ADDENDUM NO. 1

RED CLAY CONSOLIDATED SCHOOL DISTRICT
WILMINGTON CAMPUS RENOVATIONS
BID PACKAGE 'B'

This addendum is hereby made part of the Project Manual and Drawings dated 28 May 2013.

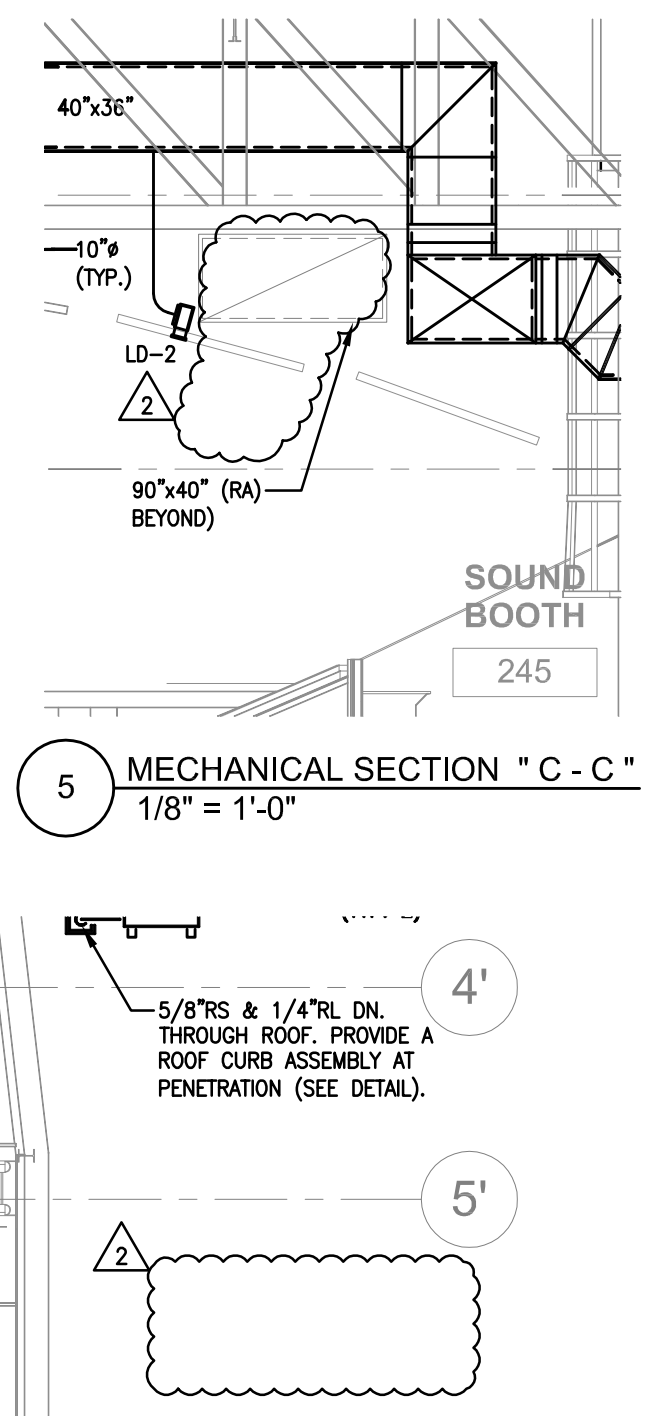
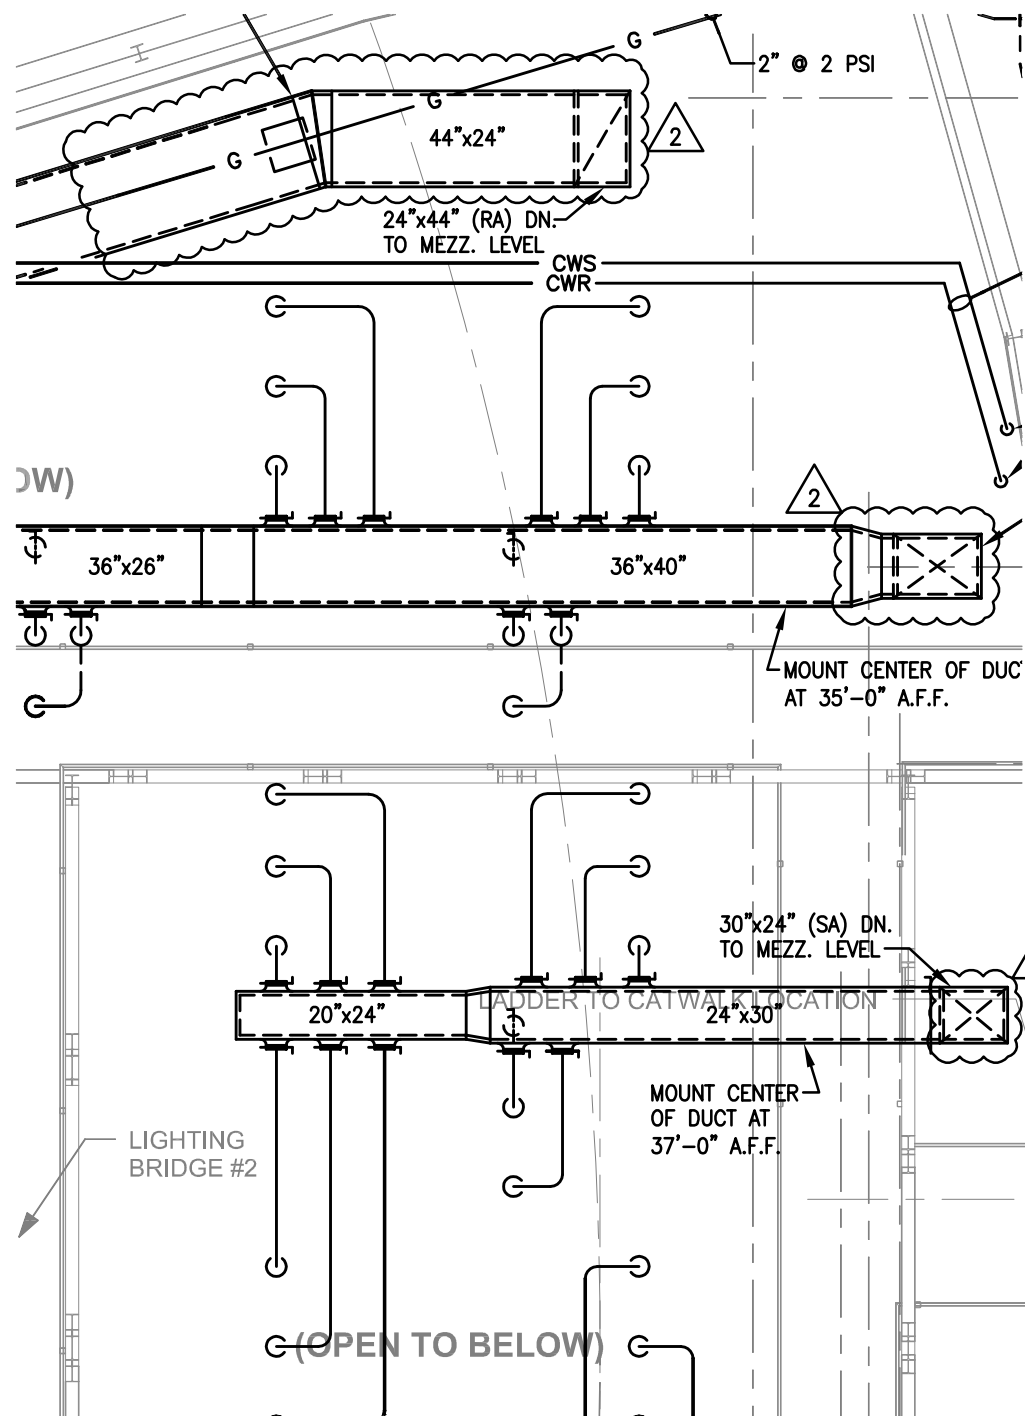
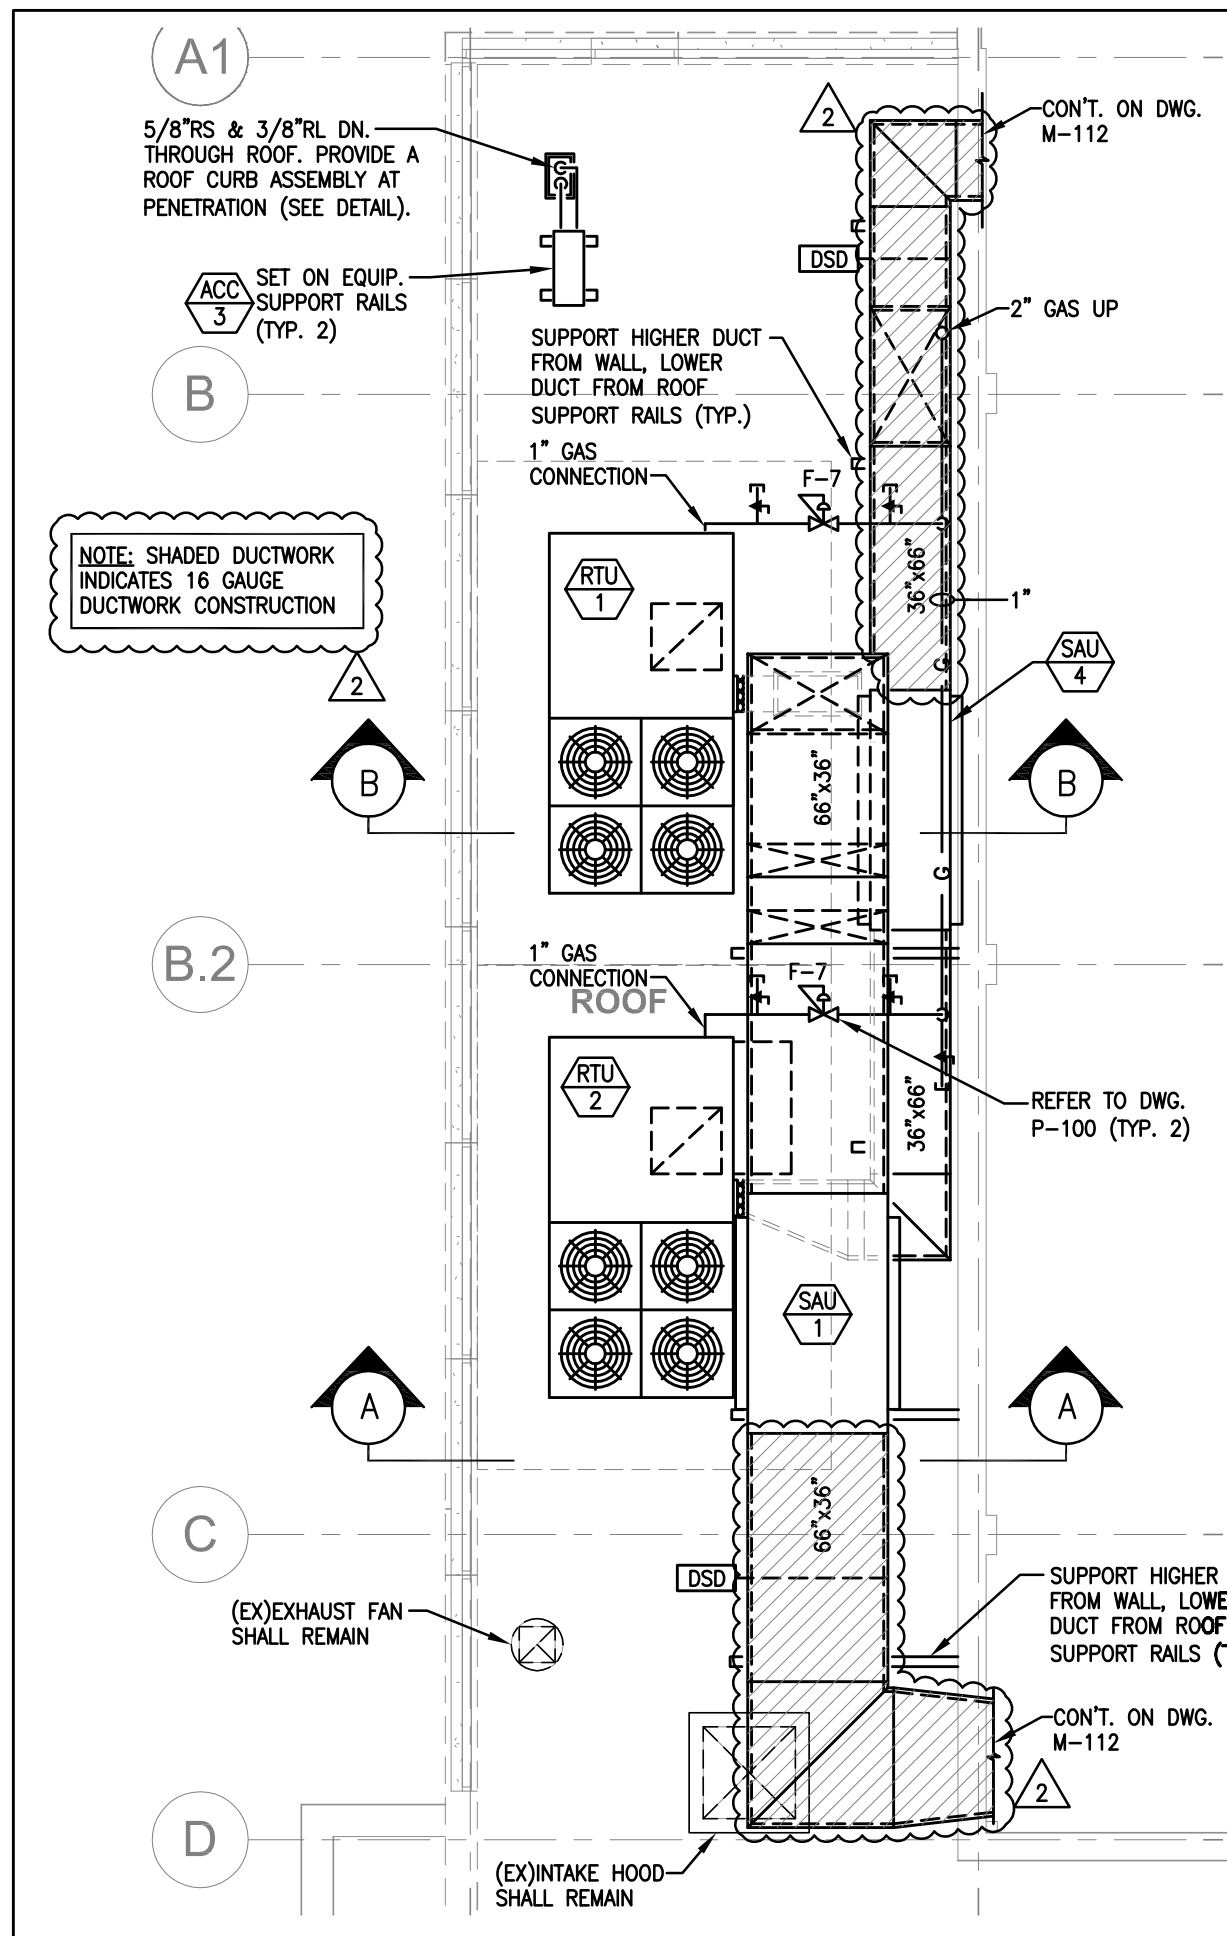
E. M-113 CATWALKS 7 ROOF MECHANICAL PLANS:

1. Remove SAU-9 from Section ‘C-C’. Refer to sketch M-702.
2. Remove SAU-8 from return duct of RTU-3. Refer to sketch M-702.
3. Remove shading and shading note from Auditorium ductwork. Refer to sketch M-702.
4. Add note and indicated location of ductwork to be 16 gauge construction. Refer to sketch M-702.
